DECISION OF THE PLANNING ADMINISTRATOR

**CONDITIONAL USE / PARTITION TENTATIVE PLAN / CLASS 3 SITE PLAN
REVIEW / CLASS 2 ADJUSTMENT CASE NO.: CU-PAR-SPR-ADJ25-03**

SUMMARY: Development of a new drive-through oil change business.

SALEM TAKE 5

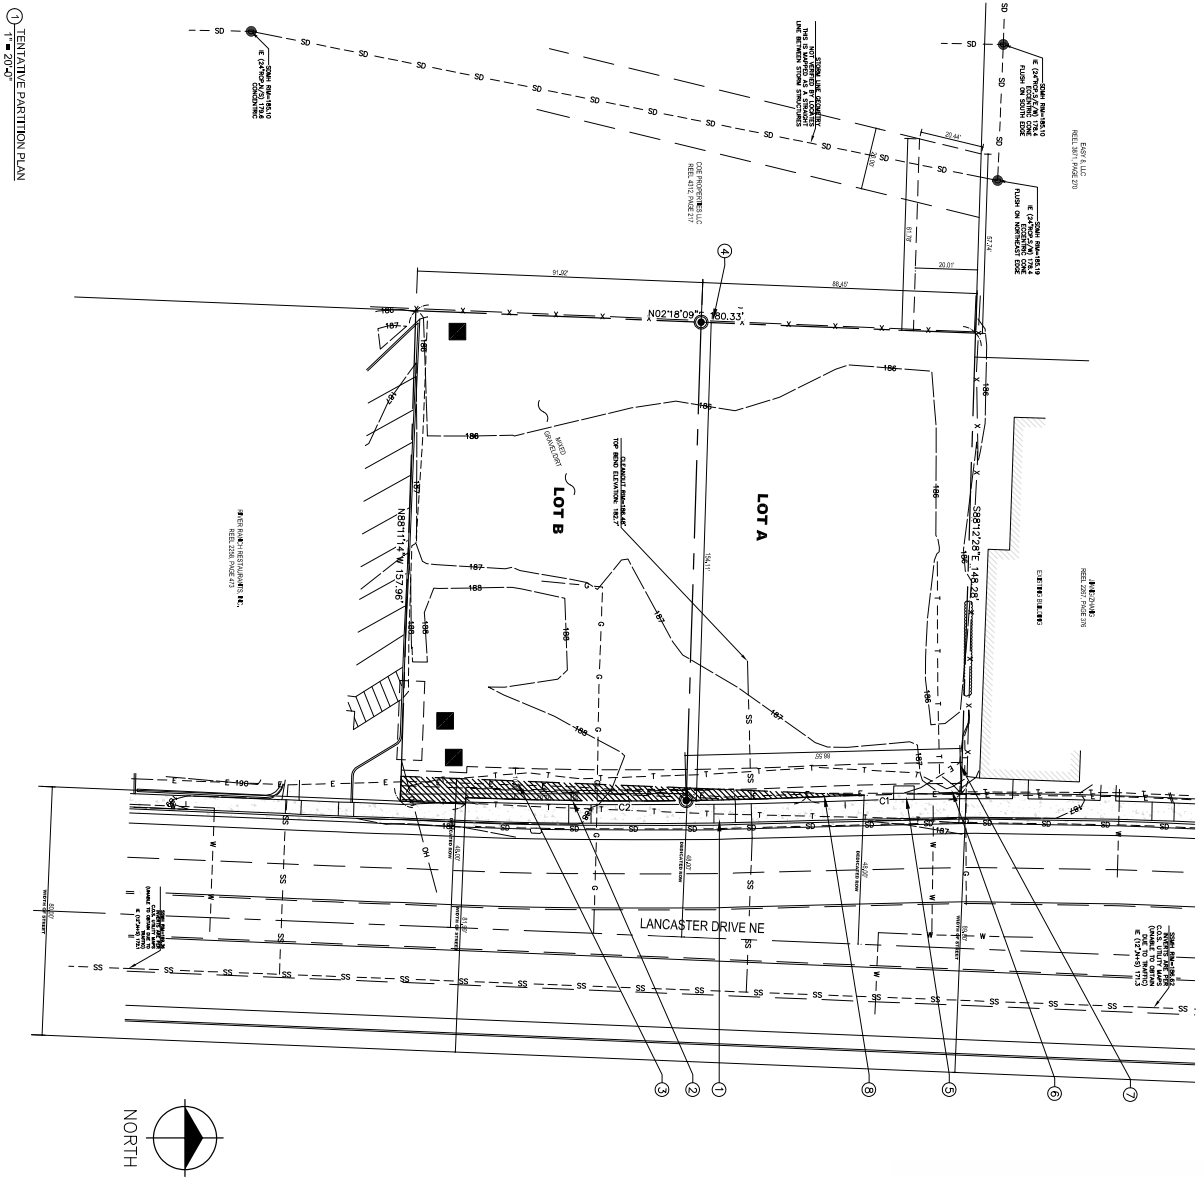
Finding 14: Lancaster Drive NE is a major arterial. SRC 804.035(a) provides that driveway approaches onto arterial streets are permitted where they provide shared access between two or more abutting properties. The applicant's tentative partition plan indicates that the existing driveway

approach to Lancaster Drive NE will be shared between proposed Parcels 1 and 2. Prior to final plat approval, the applicant shall provide a shared access easement between Parcels 1 and 2 for the driveway approach to Lancaster Drive NE.

Condition 8: On the final plat, provide a shared access easement between Parcels 1 and 2 for the driveway approach to Lancaster Drive NE.

OVERALL SITE PLAN

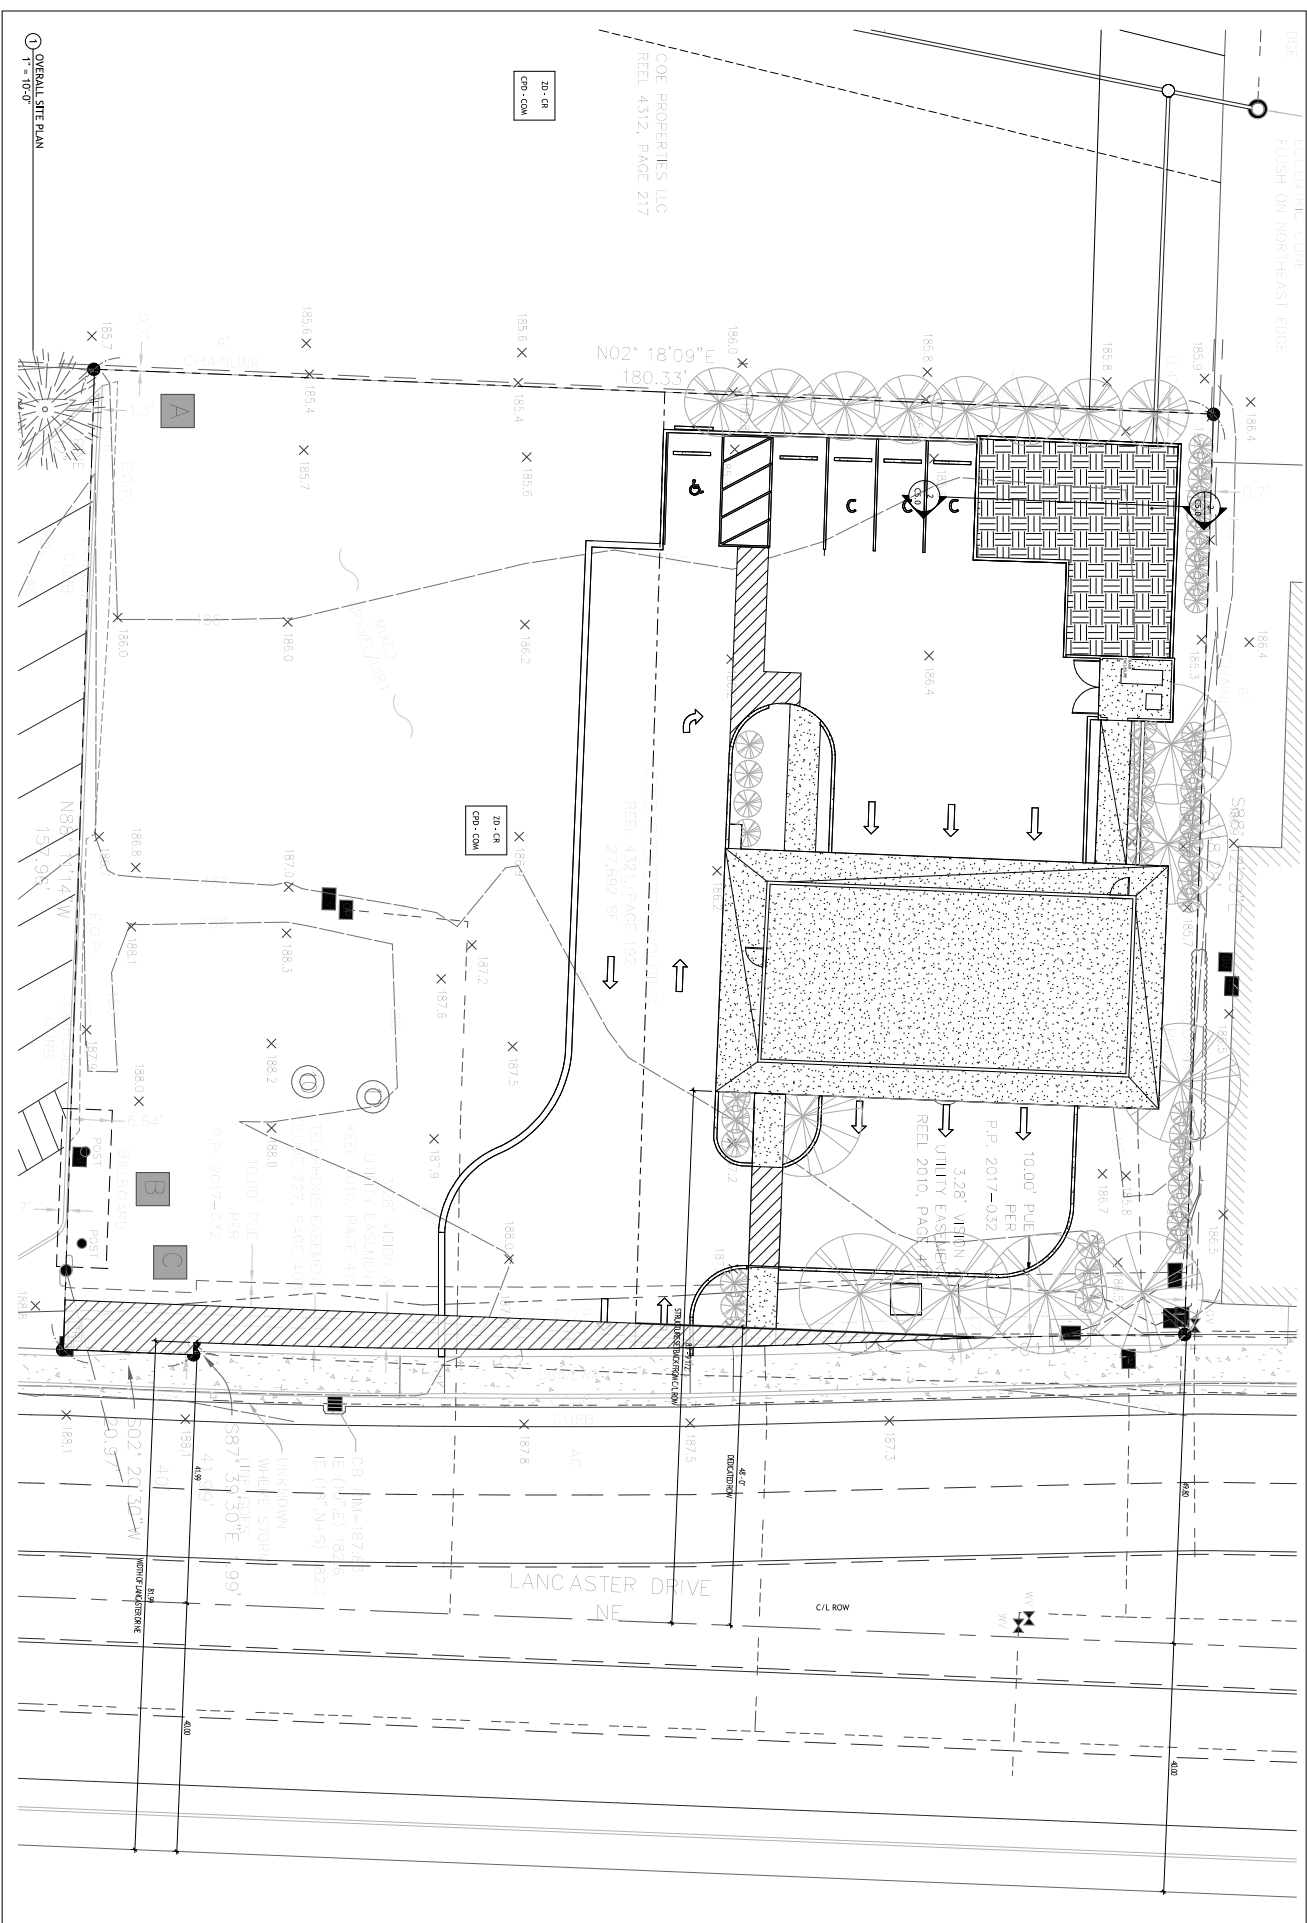
The trash containers will be screened with a 6-foot tall vinyl fence. A Class 2 Adjustment is requested as the minimum opening width of the enclosure will be nine feet instead of the required 12 feet and this fact has been communicated to the solid waste collection franchisee. The development plans indicate an enclosure opening width of nine feet with gates that will be able to swing 90 degrees.

Finding 51: SRC 800.065(b)(1) provides that required walkways be paved with a hard-surface and shall be a minimum of five feet in width. Where a walkway crosses a driveway, parking area, parking lot drive aisle or loading area it must be visually differentiated from such areas. All proposed pedestrian connections are at least five feet in width; however, the development plans indicate the connections will only be striped. To ensure the connections meet the standards of this section, the following condition shall apply.

Finding 79: SRC 802.020 requires the conveyance or dedication of easements for public and private utilities as a condition of development approval. The applicant's site plan shows a stormwater discharge for the proposed Green Stormwater Infrastructure (GSI) facility crossing over neighboring property to the west and draining to a public stormwater main that is located on private property. Prior to building permit issuance, the applicant shall obtain a private storm drain easement on abutting property to the west to connect the proposed GSI to a public stormwater main located on private property.

Condition 9: At time of building permit submittal, revise plans to provide pedestrian connections meeting the materials standards of SRC 800.065(b)(1)(B).
